***** ADDENDUM NO. 2 *****

BLUEFIELD AREA TRANSIT
ADMINISTRATION AND MAINTENANCE FACILITY

Addendum Questions and Clarifications

West Virginia Department of Transportation
 Bluefield Area Transit
 Administration and Maintenance Facility
 Bluefield, West Virginia

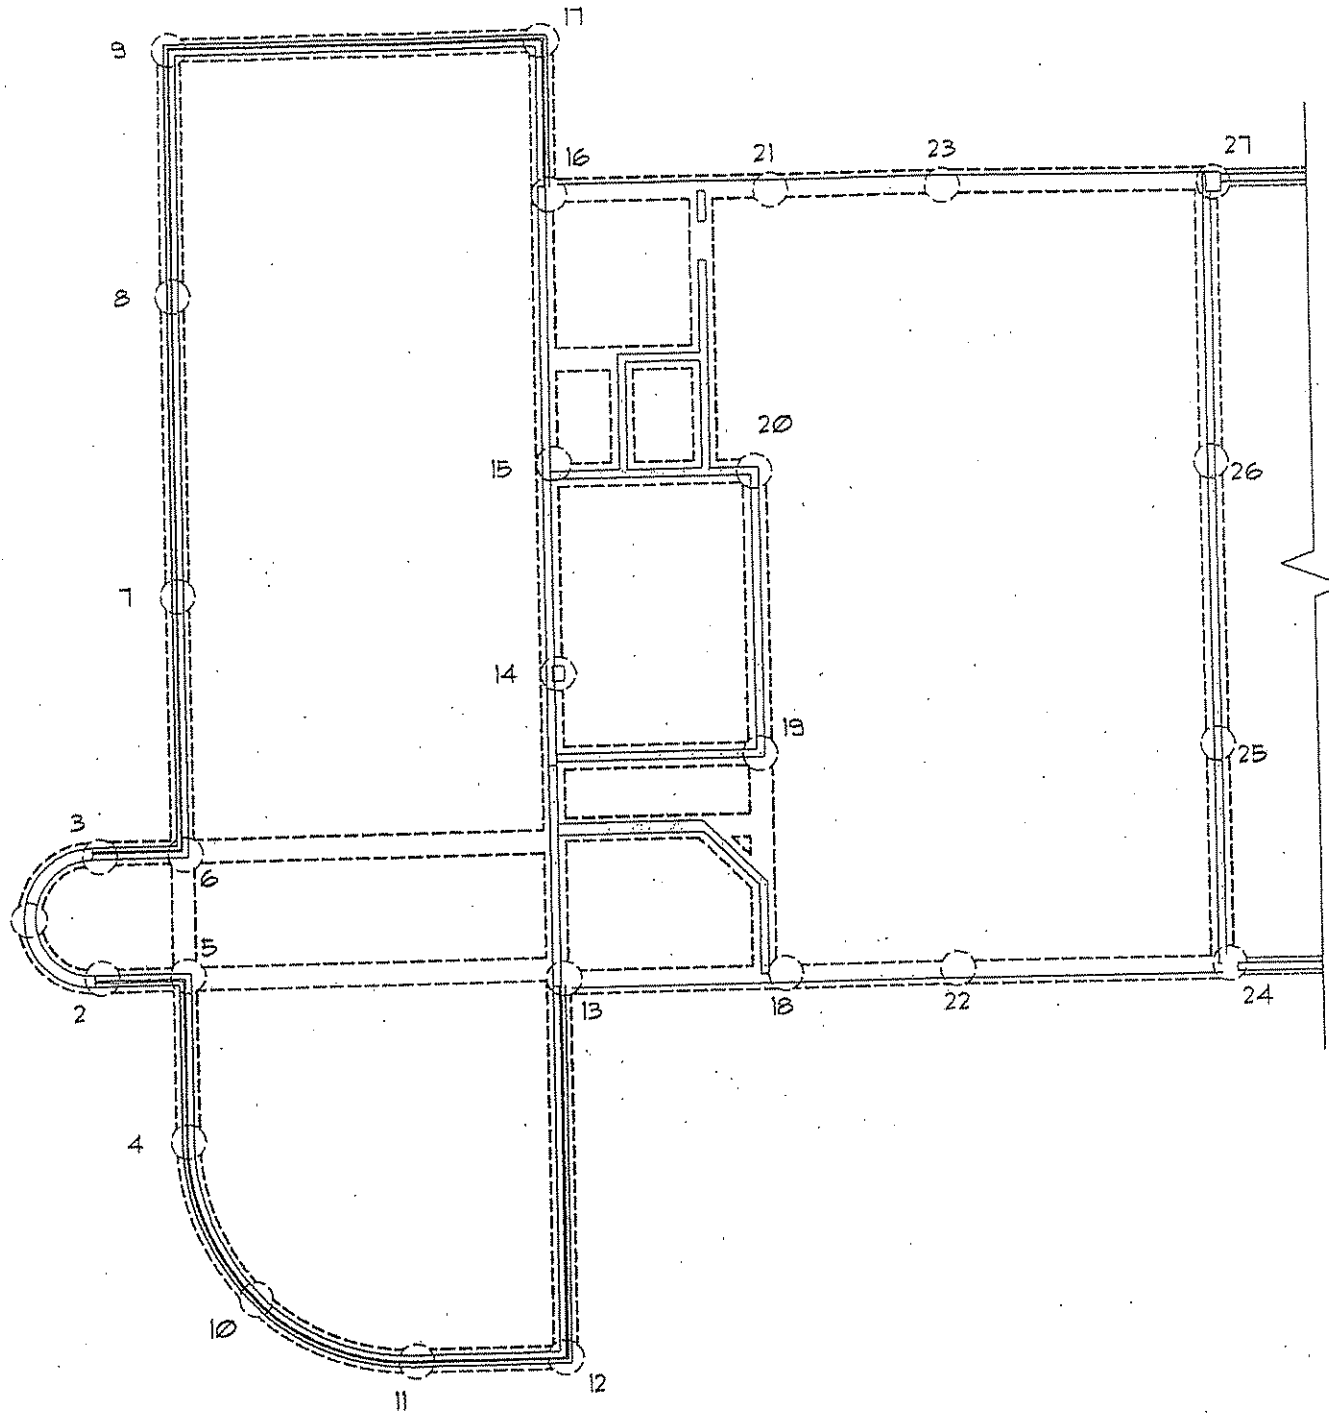
2. Need depth of Caissons?
See Attachment B, SK-1 and SK-2.
3. What is the total length of caisson shaft per shaft diameter to use on the bid?
See Attachment B for caisson information.

MARK	LENGTH
1	29'-0"
2	28'-6"
3	28'-6"
4	27'-6"
5	27'-6"
6	27'-6"
7	27'-6"
8	27'-6"
9	27'-6"
10	27'-0"
11	25'-6"
12	24'-3"
13	24'-3"
14	24'-3"
15	24'-3"
16	24'-3"
17	24'-3"
18	20'-6"
19	20'-6"
20	20'-6"
21	20'-6"
22	16'-6"
23	16'-6"
24	14'-9"
25	14'-9"
26	14'-9"
27	14'-9"

PROJECT FUNDING SOURCE SIGN ASSEMBLY AMERICAN RECOVERY AND REINVESTMENT ACT SIGN LAYOUT DETAILS

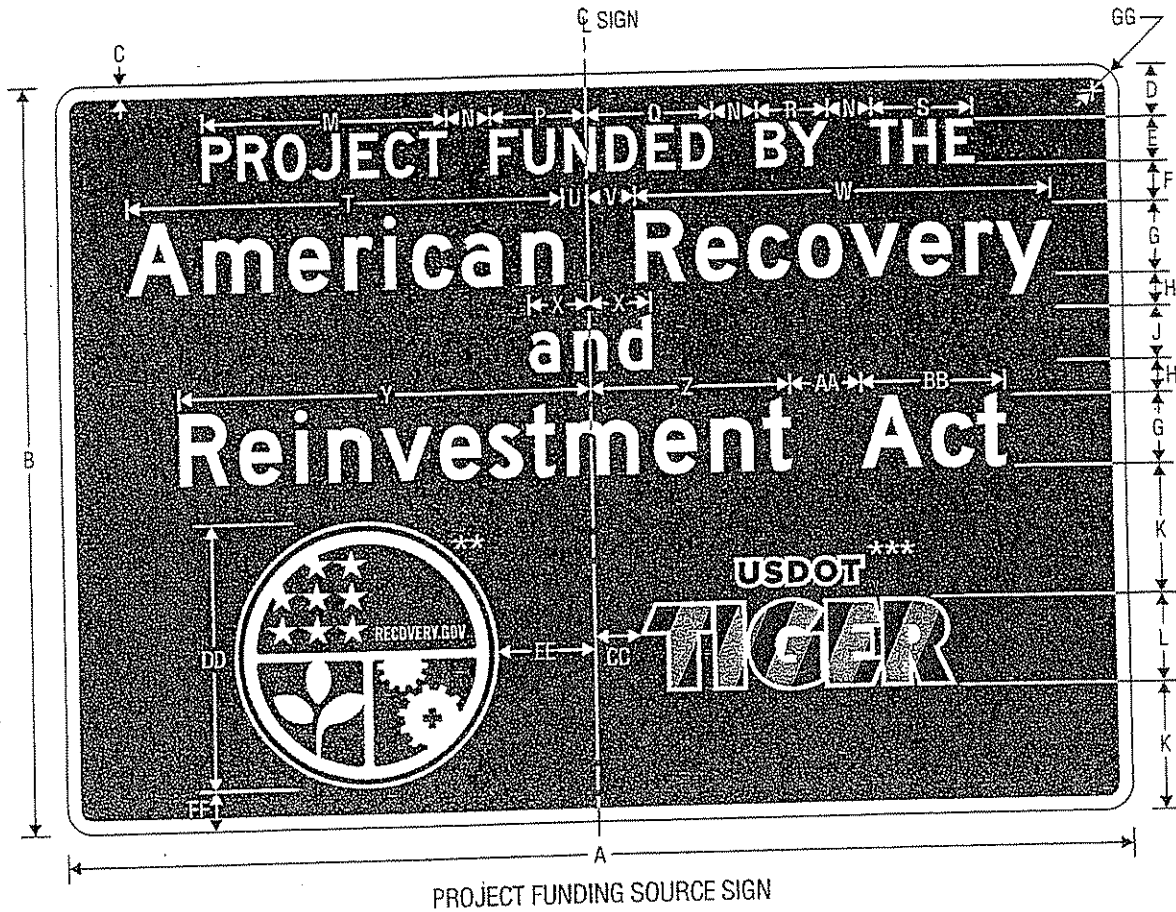
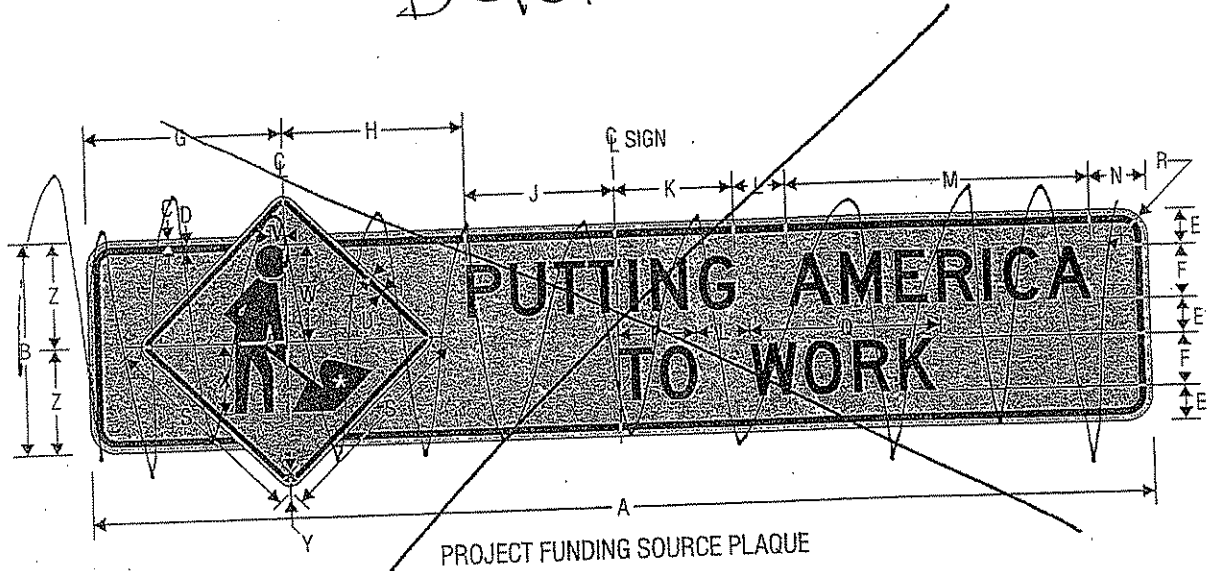
20. Provide a site sign with the American Recovery Act information, "TIGER" logo, see Attachment "D". Use the 84" wide sign dimensions. Note also that the Federal Transit Administration sign must be up on the first day of work on the job site.

Orange Sign - Delete - NOT A Requirement

Delete

ATTACHMENT "G"

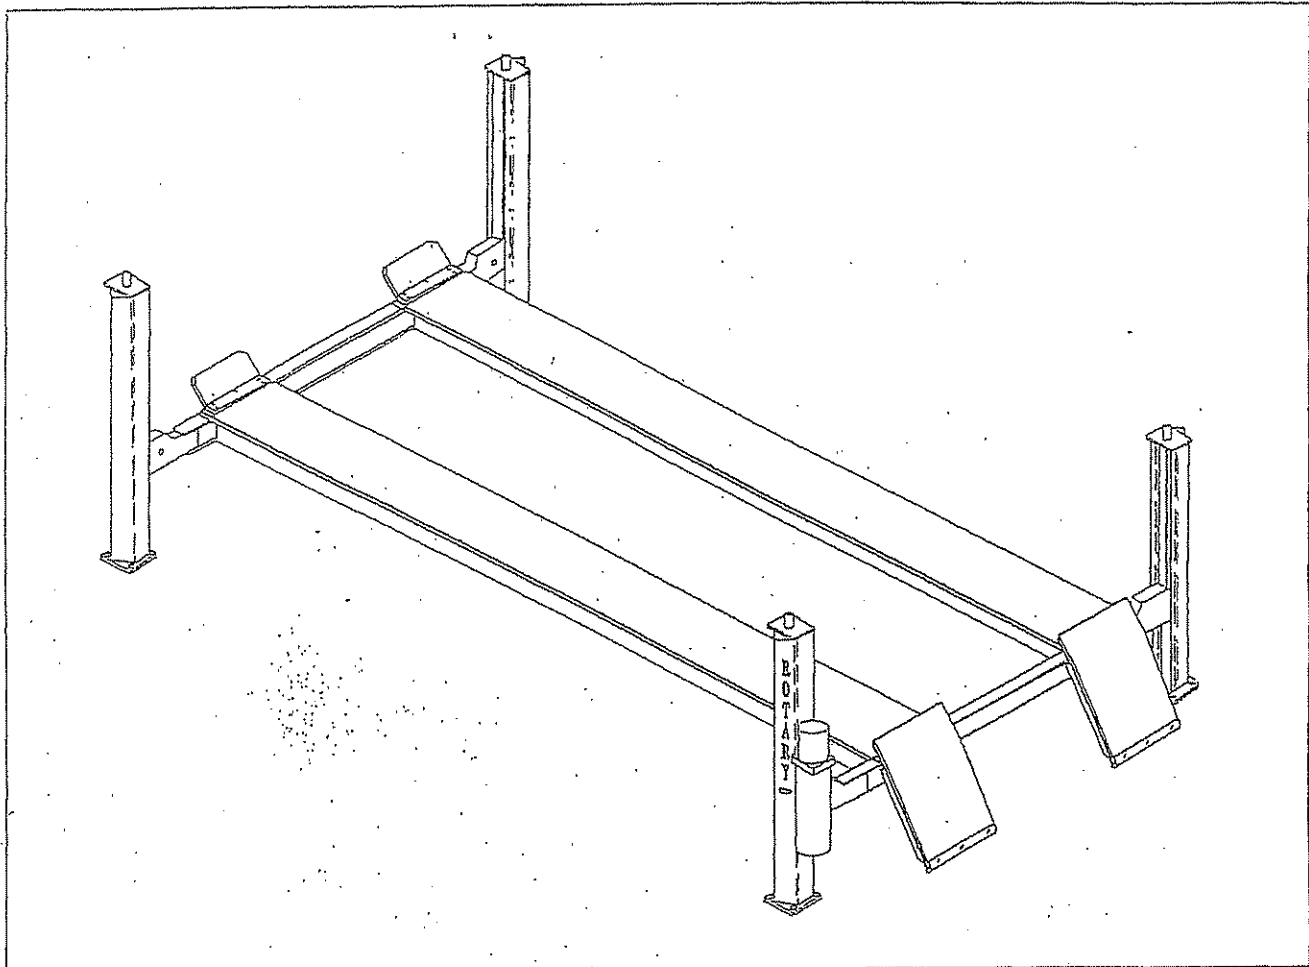
17. Sheet A1, Construction note No. 4, provide bus lift information so installation cost can be calculated.
The bus lift in the existing facility is a Rotary Lift, Model SM300-100, Capacity 30,000 lbs., Serial No. PAC 97C0002. Remove bus lift and reinstall in the new facility according to the manufacturer's written instructions. Jefferds Corporation in Saint Albans, WV (304) 755-8111, may have additional information as a local representative of Rotary Lift. See Attachment "G", for information only.

JOB NUMBER:	08050
SCALE:	AS NOTED
DATE:	APRIL 2009
DESIGNED BY:	DND
CHECKED BY:	MCD
CHECKED BY:	CONCRETE
SHEET NO.:	SK6
REVISION:

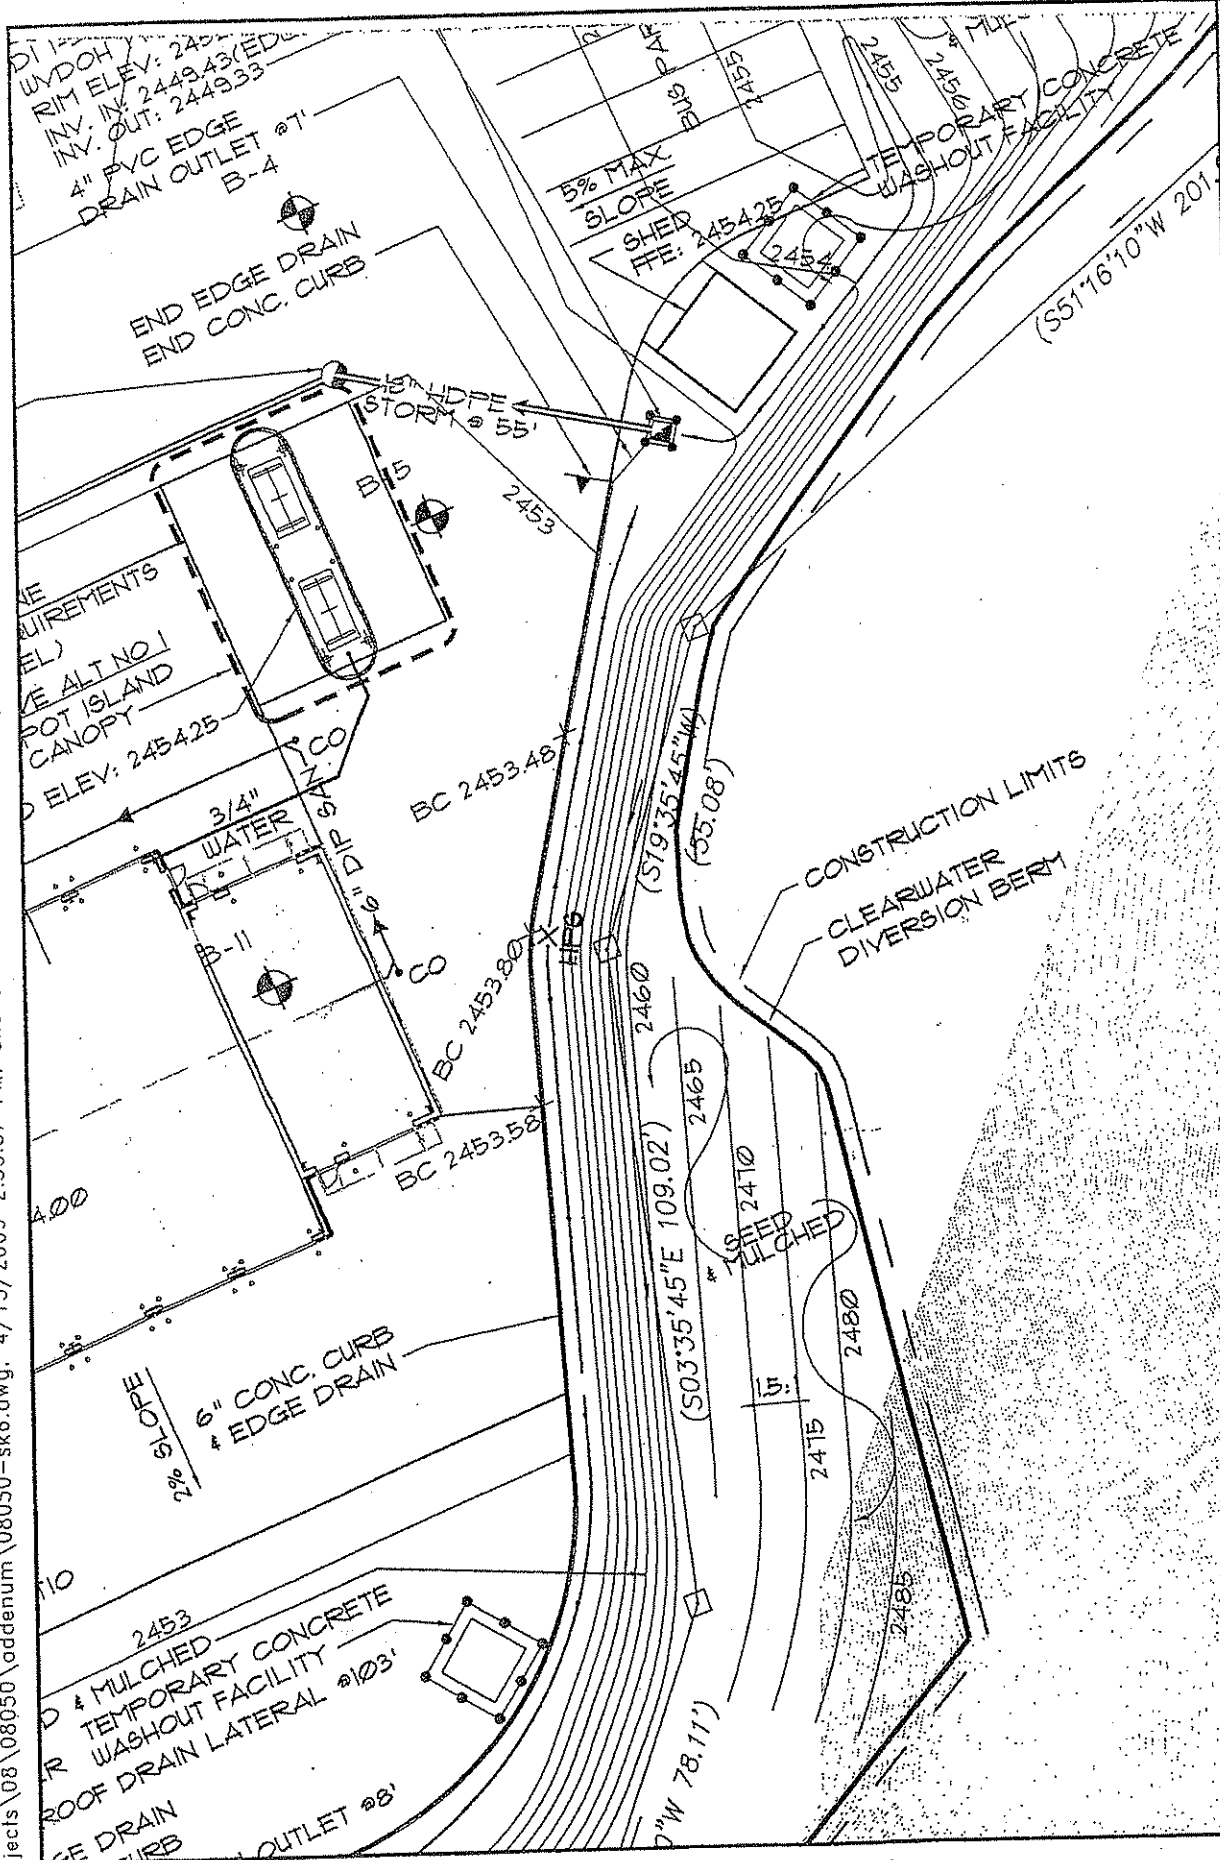
34. *Provide site signage and electronic message board as noted in Attachment "H", SK-5.*
35. *Provide Concrete Washout Locations, SK-6, Concrete Washout Detail, SK-7, and revised Inlet Infiltration Protection Detail, SK-8, as noted in Attachment "K".*

1. ACTUAL LAYOUT DETERMINED IN THE FIELD.
2. THE CONCRETE WASHOUT SIGN SHALL BE INSTALLED WITHIN 5'-0" OF THE TEMPORARY CONCRETE WASHOUT FACILITY.
